Supplement for comments #18,19,20,21,28,29,30

IEEE 802.3 interim sessions, Geneva, CH, September, 2012

Minimum channel insertion loss for PX40

Table 60–1—PMD types specified in this clause

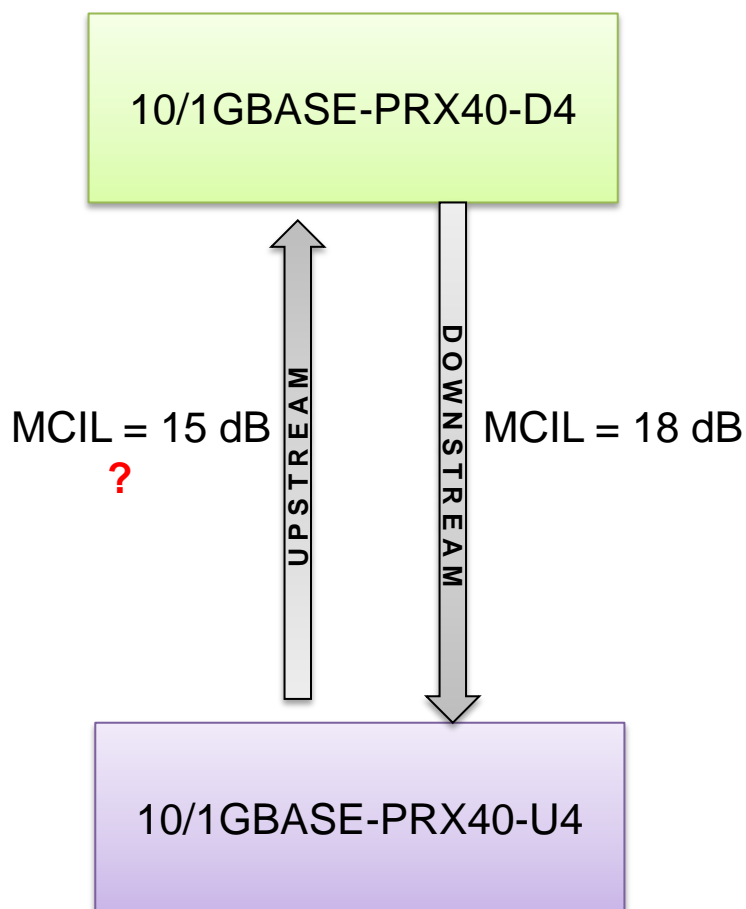
- Table 60-1 in P802.3bk D1.1 ,
 - It defined the MCIL for PX40 is 18dB.
- But the actual MCIL for PX40 Upstream is $7 - (-8) = 15$ dB, it doesn't match number in Table 60-1.
- The same problem in MCIL for PX40 Downstream is $7 - (-8) = 15$ dB.

The proposal new parameters for PX40/PRX40 US

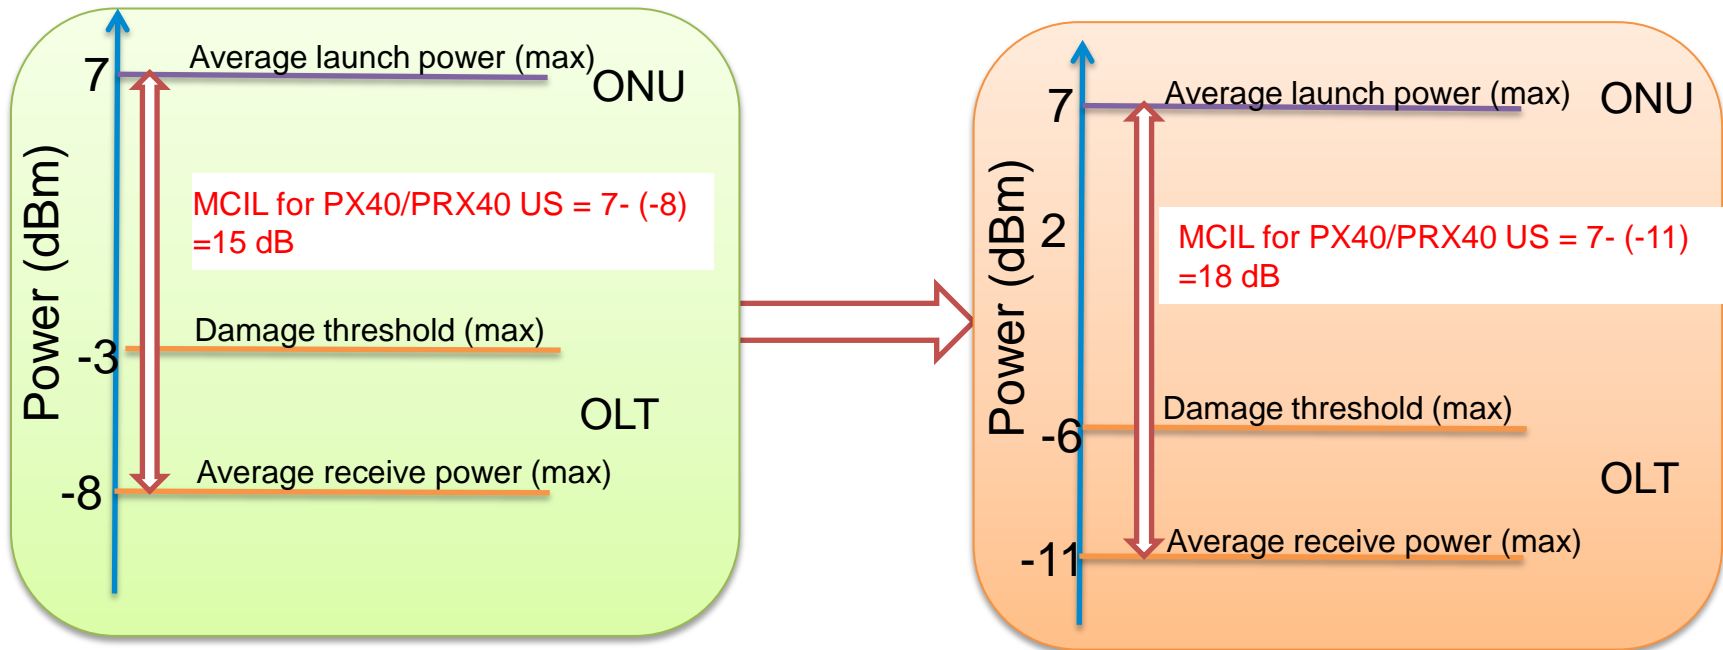
- Table 75-1 in P802.3bk D1.1,
 - Which is defined the minimum channel insertion loss for PRX40 as 18dB.
- In P802.3bk, the upstream of PRX40 is defined the same as the upstream PX40,
 - Which is showed in Table 75-7 and Table 75-9
- But the MCIL for PX40 Upstream is $7 - (-8) = 15$ dB, it is the same as PRX40 upstream , it will not match the Table 75-1 requirement.

- Average launch power (max) of 1000BASE-PX40-U is 7 dBm (in Table 60-8d).
- If changed average receive power (max) of 1000BASE-PX40-D from -8 to -11 dBm.
- Then the MCIL for PX40 /PRX40 US = $7 - (-11) = 18$ dB.
- And, the damage threshold (max) of 1000BASE-PX40-D should be reduced from -3 to -6 dBm

Solution 1

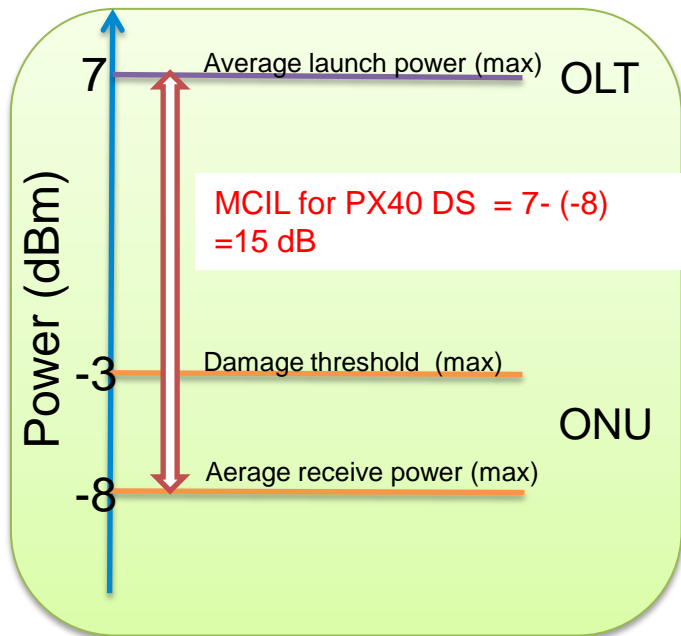
The new parameters solutions for PX40 DS

- Increase the OLT power, reduce the ONU average receive power and damage threshold
